CITY PLANNING COMMISSION
1231 "I" STREET, SUITE 200, SACRAMENTO, CA. 95814

- APPLICATION:**
- A. Negative Declaration
 - B. Tentative Map to create 14 petite single family lots and a common lot for a private street on 1.9± vacant acres in the Single Family Alternative (R-1A) zone
 - C. Special Permit to construct 14 petite units in the R-1A zone
 - OK** D. Subdivision Modification to establish double frontage lots and private street

LOCATION: Southeast corner of 65th Street Expressway and Elder Creek Road

PROPOSAL: The applicant is requesting the necessary entitlements to develop a 14-unit petite single family subdivision served by a private street.

TENTATIVE MAP

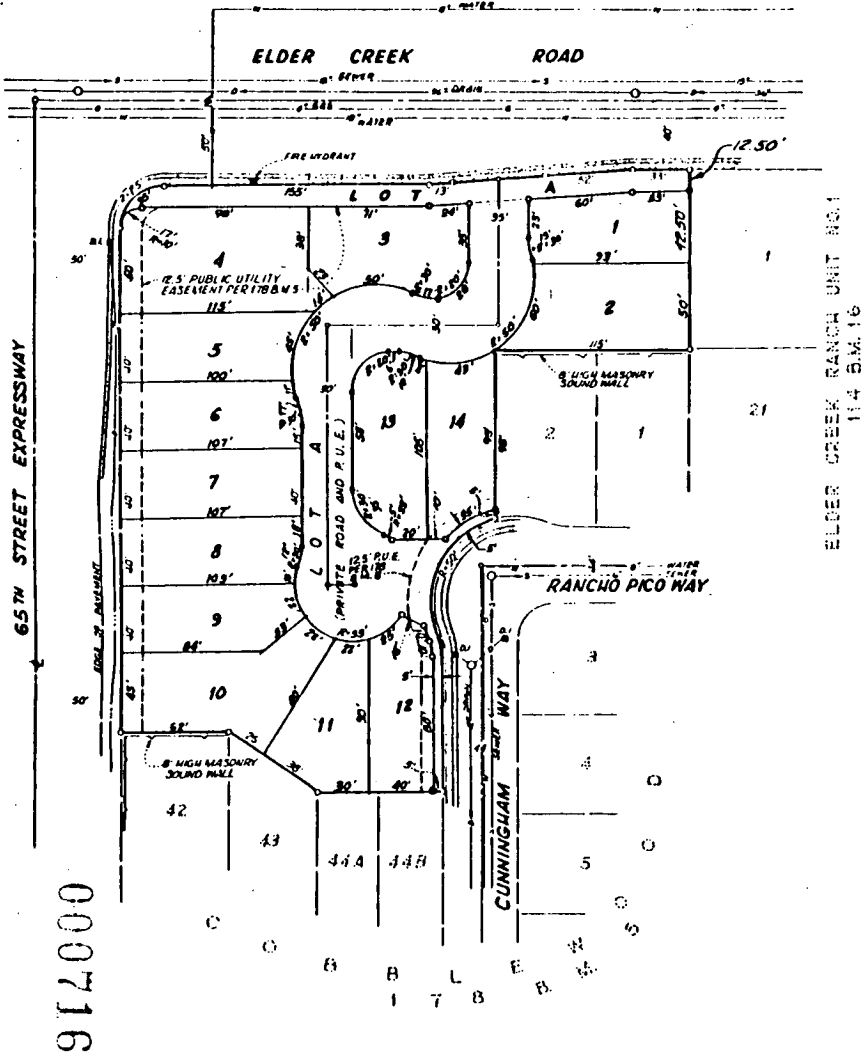
Access will be provided off Elder Creek Road on a 31 foot wide private street constructed to City standards. All improvements are to be installed and inspected to City standards. Staff originally requested redesign of the project to provide access off Rancho Pico Way and not provide access off Elder Creek. Public Works Department determined that access off Elder Creek would be acceptable. This results in one lot with three street frontages and two through lots. A more conventional subdivision design could be achieved for the site, however the unit count is decreased. Since access internal to the site is off a private street to be maintained by a homeowners' association, staff has no objection to the establishment of through lots or a lot with three street frontages.

One issue raised by planning is the responsibility for maintenance of landscaping between the fence and right-of-way for Rancho Pico Way frontage. Since this serves as a rear yard area, staff is concerned that any solid wall or fence constructed along Rancho Pico may be a place for graffiti and weed build-up due to its remoteness from access to the project site. Staff recommends that a decorative wrought iron fence, six feet in height, be constructed along the Cumingham-Rancho Pico Way frontage so that residents of the development are forced to maintain the area and not ignore it. The fence will also deter graffiti and provide rear yard security. If homeowners wish to add privacy screen fencing, it should be as shown on Exhibit C, staff modified site plan. The open area could be used as a common recreation area and be maintained by the homeowners' association.

20. A homeowners' association shall be formed and C.C. & R's shall be approved by the City assuring maintenance of private roadway landscaped areas adjacent to walls and fences and common landscaped areas. The homeowners' association shall maintain all streets, lights, sewers, drains, and water systems. Map shall be revised to increase size of Lot A to the satisfaction of the Planning Director.

13. Dedicate a standard 12.5-foot public utility easement for underground and over-head electrical facilities and appurtenances adjacent to private drive on Lots 1 to 9, 13 and 14. Dedicate a 7-1/2-foot public utility easement adjacent to Lots 10, 11, 12;

14. Left turns to and from Elder Creek Road shall be prohibited. Median island shall be extended in Elder Creek Road to the satisfaction of the Traffic Engineer;

ELEVATIONS

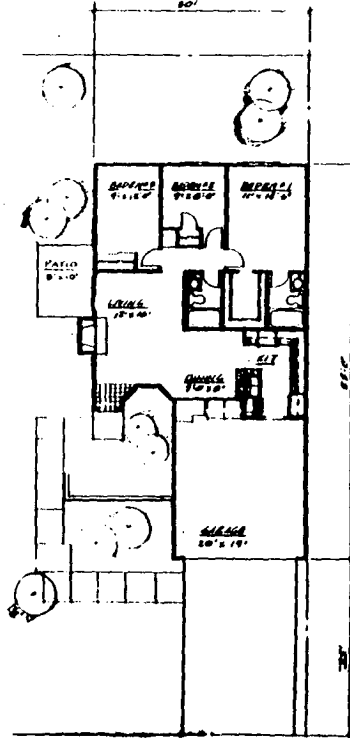
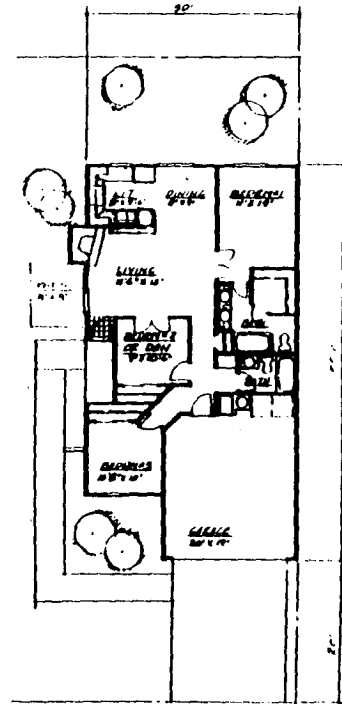
The applicant proposes two floor plans of 1,009 square feet and 1,132 square feet in a zero-lot-line development. A ten-foot building maintenance easement and setback will be required between the units where doorways are opposite property lines. Staff has reviewed the elevations and recommends use of stucco, wood trim, and a mix of horizontal masonite siding with other materials including brick veneer or window sill treatments. For sound attenuation, special treatments are required for elevations facing 65th Street Expressway. Staff also recommends planting of one tree per lot and landscaping of the wall and fence areas adjacent to public right-of-ways. This landscape area is to be maintained by the homeowners' association and not the City.

Staff recommends that detailed elevations be reviewed and approved by staff prior to issuance of building permits. Detailed landscaping plans, decorative wall and wrought iron fence details are to be reviewed and approved by staff prior to issuance of grading or construction permits for the site.

1. Revised detailed elevations for the units shall be approved by Planning staff showing a mix of stucco, horizontal wood siding and brick veneer prior to issuance of building permits. Roof materials shall be 30-year heavy grade composition shingle or better.
2. A minimum of one tree shall be planted per yard. Trees shall be five gallon specimen selected from approved City tree list. An overall site plan of the project indicating the location and species of all trees shall be submitted for Planning Director review and approval prior to issuance of building permits.
